SERVICE LETTER 185

10000 Nutplate Installation

Aircraft Makes/Model(s):	Float Model(s):	Compliance: Optional	By: MAB
AT-802 AT-802A	10000A	Part Number: 1009886	Approved: SDW
		Date: 10/22/2019	Revision: C

Nutplate Strip

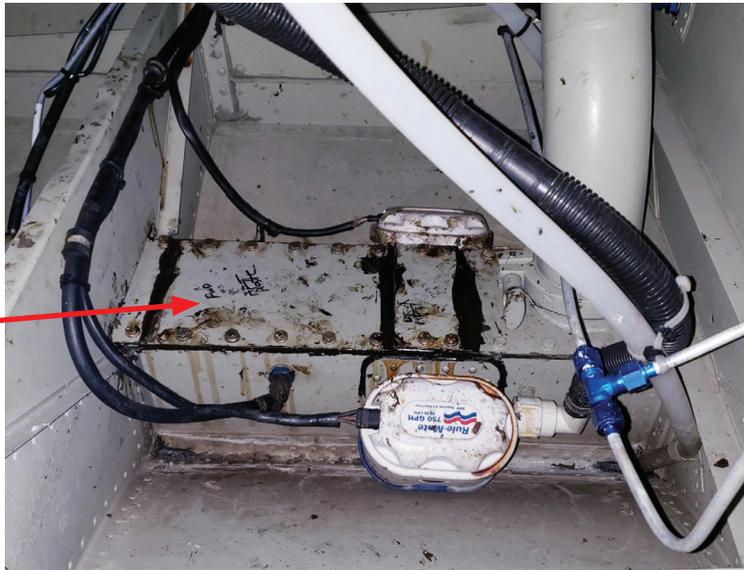
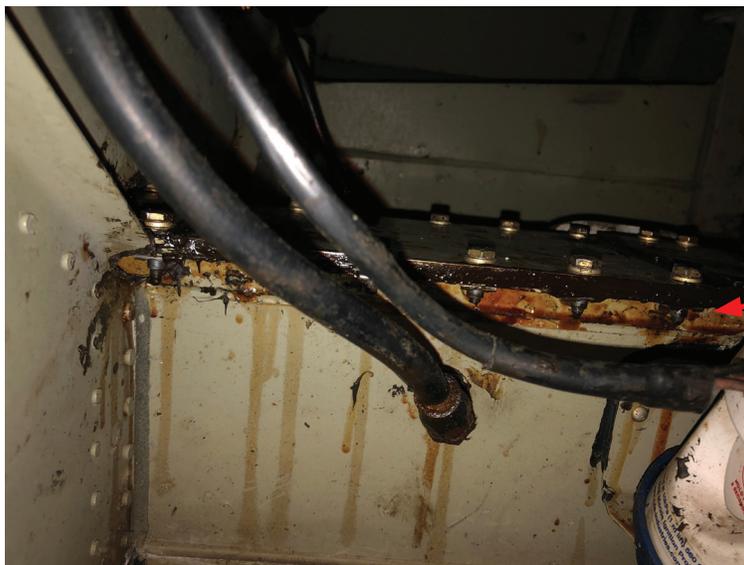
Traditionally, the scoop tunnel on the Air Tractor uses nuts, washers, and bolts. Due to tight quarters, it is difficult to access when performing maintenance. This service letter provides a nutplate strip installation for easier maintenance in the future.

1. Access scoop tunnel through aft panel in foam/baggage compartment.
2. Remove hardware and covers on top of scoop tunnel.
3. Discard hardware (nuts and washers) on bottom of scoop tunnel flange.
4. Clean sealant from covers and top and bottom of flanges.
5. Reinstall covers with PR-1422 or equivalent using nutplate strips on bottom and existing bolts and washers.
Note: 1009724 (10.15") goes forward and 1009725 (11.60") goes aft.
6. Leak check scoop tunnels.
